## REQUEST FOR INFORMATION (RFI)

PROJECT :	BKK2	R.F.I. NO. :	523213-01-RFI-AR-0005
TO :	CTA	ATTENTION :	CTA
SUBMITTED DATE:	20-Jan-26	NEED REPLY BY DATE :	27-Jan-26

SUBJECT : Request for Confirmation - Partition wall or a block wall for Chiller Riser 2nd 3rd 4th and 5th Floor

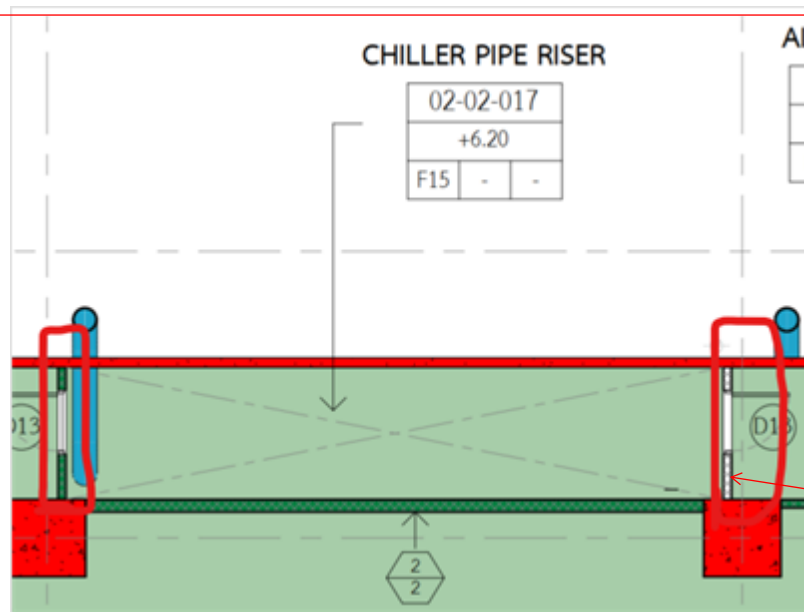
Kindly clarify, with reference to the IFC drawings, whether this area is to be constructed as a partition wall or a block wall for Chiller Riser L2 L3 L4 L5

SLA: It is a block wall from 2F to 5F. The wall between 4/B to 5/B need to coordinate with the chiller pipes support.

This is block wall (wall material 2 / wall finish 2) from 2F to 5F.
